APPLICATION NO.	FILING DATE	FIRST NAMED INVENTOR	ATTORNEY DOCKET NO.	CONFIRMATION NO.
10/549,375	01/26/2007	Andrew Michael Wild	148392-110066	3476

Office Action Summary	Application No. 10/549,375	Applicant(s) WILD, ANDREW MICHAEL	
	Examiner DIANNE DORNBUSCH	Art Unit 3773

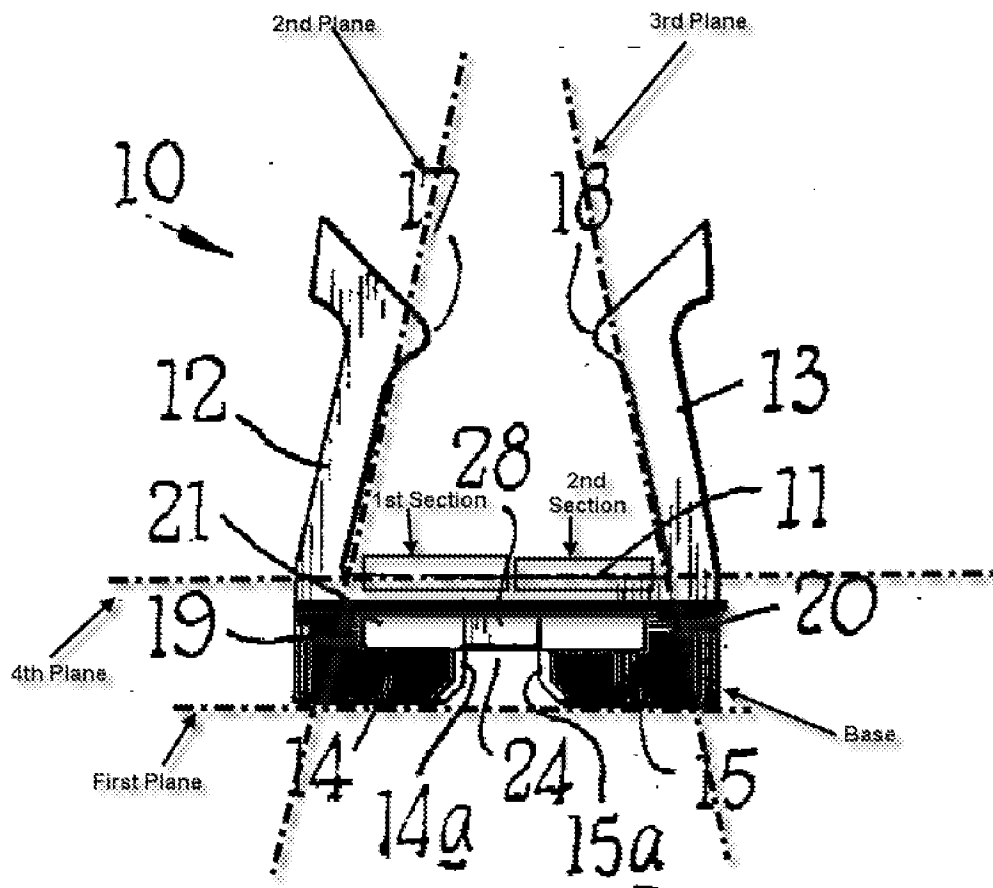
Claim 24: A generally planar base portion (see figure below where the area filled is the base) defining a first plane (see figure below); a first resilient arm (12) extending from the base portion (figure below) and having a curved distal end portion (17) defining a

first contact surface (inner surface of the arm and curved portion) and disposed in a second plane (see figure below) offset to a first side of the first plane (figure below and Fig. 6-7 where the contact surface is contacting part 16); a second resilient arm (13) extending from the base portion and having a curved distal end portion (18) defining a second contact surface (inner surface of the arm and curved portion) and disposed in a third plane (see figure below) offset to a second side of the first plane (figure below and Fig. 6-7 where the contact surface is contacting part 16), whereby the first and second contact surfaces curve generally toward each other (Fig. 6-7); and a third contact surface (11) defined by a section (the two sections as seen in the figure below form the section (Fig. 5)) extending from the base portion (see figure below), an elongate reaction surface (the reaction surface is the surface of 11 that contacts the part 16 which reacts by exerting a normal force on the part 16) and disposed on a fourth plane (see figure below) offset from the first plane and distinct from the second and third planes; whereby the third contact surface is disposed generally between the first and second arms when the clip is viewed parallel to the first plane (see figure below); whereby the first and second arms can pivot independently of the third contact surface (Fig. 1, 5-7), whereby the offsetting of the planes (examiner is interpreting it as the offset of the resilient legs which comprises that first resilient arm and the second resilient arm are offset from the third contact surface (Fig. 1 and 5)) such that in a closed condition of the clip, the first contact surface contacts the body passageway at a first longitudinal position on the body passageway, the second contact surface contacts the body passageway at a second longitudinal position and the third contact surface

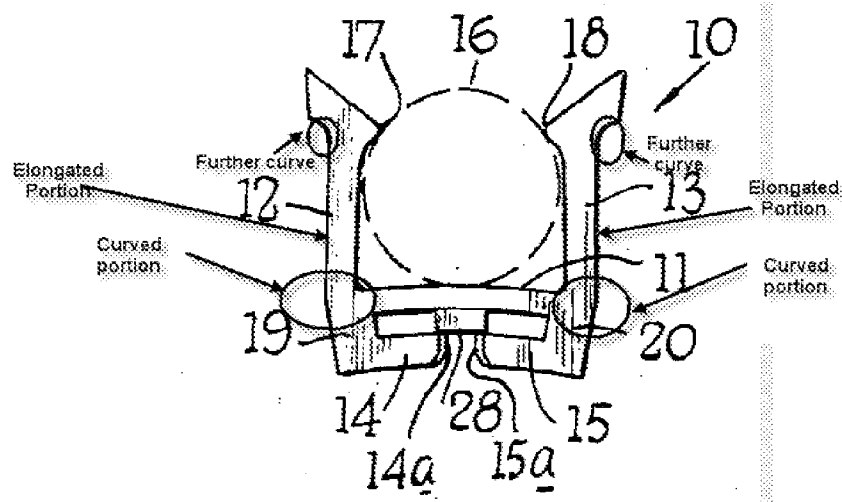
Claim 14: Each limb is connected to the base portion of the clip via a curved portion of the limb (see figure below) defining a connection point to the base portion behind the reaction portion of the clip (see figure below).

Claim 15: A further curve (see figure below) is provided in the limb in the opposite direction to the said curved portion, whereby the free end of the limb is disposed forward of the base portion of the clip (see figure below).

Claims 16 and 22: An elongate portion (see figure below) is provided in each limb between the curves (see figure below), whereby during closure a leverage effect is produced on the part of the limb which is in contact with the body passageway (Fig. 5-7).

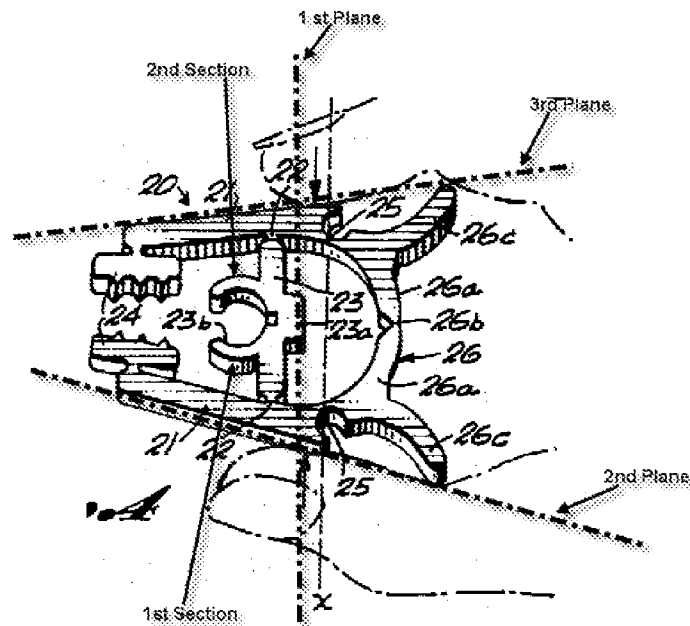
Claim 24: A generally planar base portion (23 and 23a) defining a first plane (see figure below); a first resilient arm (21) extending from the base portion (Fig. 3) and having a curved distal end portion (Fig. 3-4) defining a first contact surface (24) and disposed in a second plane (see figure below) offset to a first side of the first plane (figure below); a second resilient arm (21) extending from the base portion and having a curved distal end portion (18) defining a second contact surface (24) and disposed in a third plane (see figure below) offset to a second side of the first plane (figure below), whereby the first and second contact surfaces curve generally toward each other (Fig. 3-4); and a third contact surface (23b) defined by a section (the two sections as seen in the figure below form the section) extending from the base portion (see figure below), an elongate

reaction surface (23b) (Fig. 5) and disposed on a fourth plane (see figure below) offset from the first plane and distinct from the second and third planes; whereby the third contact surface is disposed generally between the first and second arms when the clip is viewed parallel to the first plane (see figure below); whereby the first and second arms can pivot independently of the third contact surface (Fig. 3-5), whereby the offsetting of the planes (examiner is interpreting it as the offset of the resilient legs which comprises that first resilient arm and the second resilient arm are offset from the third contact surface (Fig. 3-5)) such that in a closed condition of the clip, the first contact surface contacts the body passageway at a first longitudinal position on the body passageway, the second contact surface contacts the body passageway at a second longitudinal position and the third contact surface contacts the body passageway at a third longitudinal position (Fig. 5), such that the body passageway is contacted at three longitudinally distinct locations by the first, second and third contact surfaces (Fig. 5), and whereby the co-operation of the first, second and third contact surfaces can compress the body passageway and substantially reduce the diameter of the body passageway, so as to substantially prevent the flow of fluid through the passageway.

Furthermore, the device of Esposito can receive the body passageway in an open condition between the third contact surface and the distal end portions of the first and second arms and the arms can close resiliently towards the third contact surface to a closed condition in which the base portion and the third contact surface oppose the distal end portions of the arms across the body passageway with the third contact surface contacting and compressing the body passageway from one side thereof and the first and second contact surfaces contacting and compressing the body passageway from the other side thereof (Fig. 4-5 where the passageway would be more compress depending on the tube material used such as a more flexible one than the clip can compress it more. Furthermore, the tube can be hold by the resilient legs and depending on the diameter and wall thickness of the tube the third contact surface would also be contacting the tube); the reaction surface and the arms being dimensioned and arranged so that, in said closed condition of the clip, substantially the entire transverse width of the occluded body passageway is in contact with the reaction surface (Fig. 4-5).

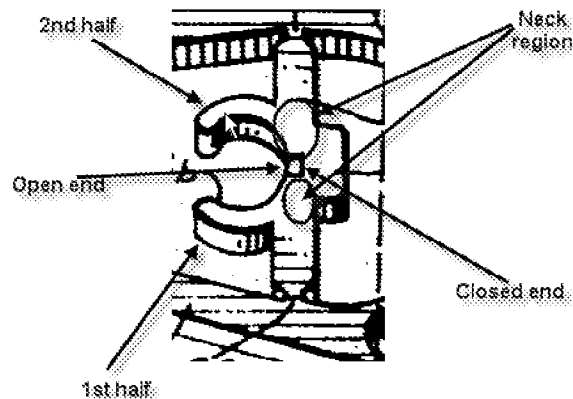
Claim 17: The base portion of the clip is in the form of an open loop or generally U-shaped member (23a is in u-shape) having a closed end directed away from the limbs (see figure below) and an open end (see figure below) at which the limbs and the reaction portion are connected to the base portion (Fig. 3).

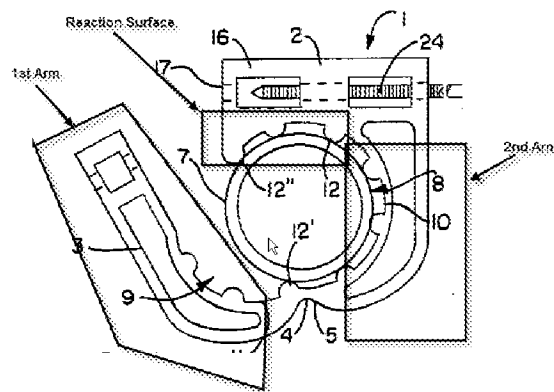
Claim 18: The reaction portion of the clip is provided in two halves (see figure below), each half is connected to one side of the open end of the base portion via a neck region (see figure below) and which are complementarily juxtaposed to define the reaction surface of the clip (see figure below).
